Subject: Submission to Amended Plans for DA 2020/0431 1129-1131 Pittwater Road
Collaroy

Re: Submission to DA 2020/0431 Amended Plans for a 4 Storey Mixed Use Building (2 commercial units & a boarding house) at 1129-1131 Pittwater Road, Collaroy

Photo 1 - 1-5 Collaroy Street North-Eastern Apartments

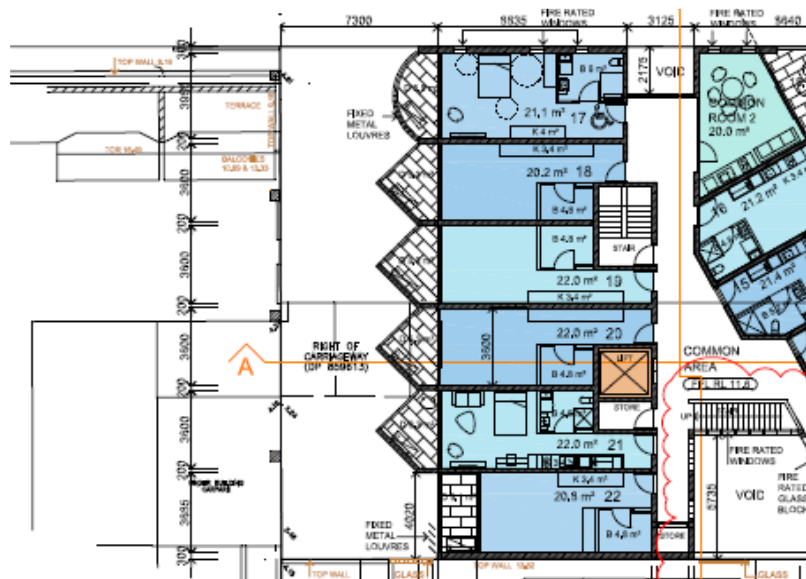
In our previous submission we raised concerns in relation to aural and visual privacy impacts of the west facing boarding room balconies in the northern half of the proposed building. The eastern elevation of the northern portion of our client's apartment building extends along the rear boundary of the development site, as shown below in **Photo 1**. The 4 northernmost balconies of the proposed building (2 on Level 1 and 2 on Level 2) are adjacent to the eastern side of the glass balustraded balconies of the north-eastern units in our client's apartment building and the east facing windows of the top floor Unit 44. **Figure 1** further below, shows the location of the west facing balconies proposed for the boarding house room along the western elevation of the proposed building.

The proposed basement carpark requires excavation to a depth of approximately 2.5m along the shared common boundary with our client's land. As shown in **Photo 1**, our client's building is supported by structural columns located along this boundary. Our client's is concerned that excavation for the proposed basement could compromise the structural integrity of these supporting columns.

It is essential that excavation for the proposed basement be undertaken in a manner that does not impact on the structural integrity of our client's supporting columns and the basement designed and constructed to ensure the ongoing structural integrity of our client's building. We consider there is insufficient information provided with the proponent's DA to satisfactorily address this issue.

Should the proposed development be approved, it is requested that any consent issued should be as a deferred commencement consent, with a requirement that full structural details be provided for the proposed basement and be accompanied by a structural engineer's report confirming that that excavation and construction methodology will not impact on the structural integrity of our client's building and the associated supporting columns along the shared common boundary.
